## Special Notice

**15-001** 7 December 2015

## Wilkins – Bypass Assembly Reduced Pressure Principle Assembly Model 975XLD 3/4-inch

## Flat Boss

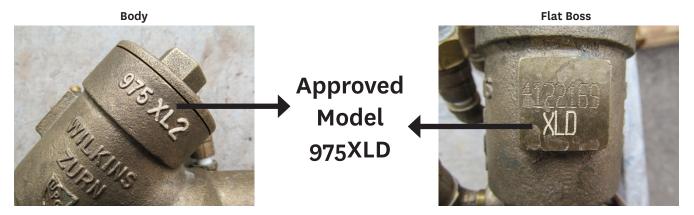
Special Notice 14-002 was issued on 22 September 2014 detailing that the USC approved Wilkins 3/4" Model 975XLD assembly was produced for a period of time with both the "975XL2" designation cast in the body of the assembly, and the "XLD" designation stamped on the flat boss below the serial number as illustrated below.

Assemblies marked as illustrated above are considered an USC approved Wilkins 3/4" Model 975XLD assembly.

As detailed in the *Special Notice 14-002*, the model designation "975XLD" was to be stamped on the flat boss on the body as of 16 September 2014, and starting serial number 3981297.

However, this change did not get fully implemented into production at that time. The markings have now been corrected and have been implemented into production as of 23 October 2015 and starting serial number 4165946.

The "975XL2" will remain cast into the body and the "975XLD" model designation is stamped on the flat boss below the serial number on the body.
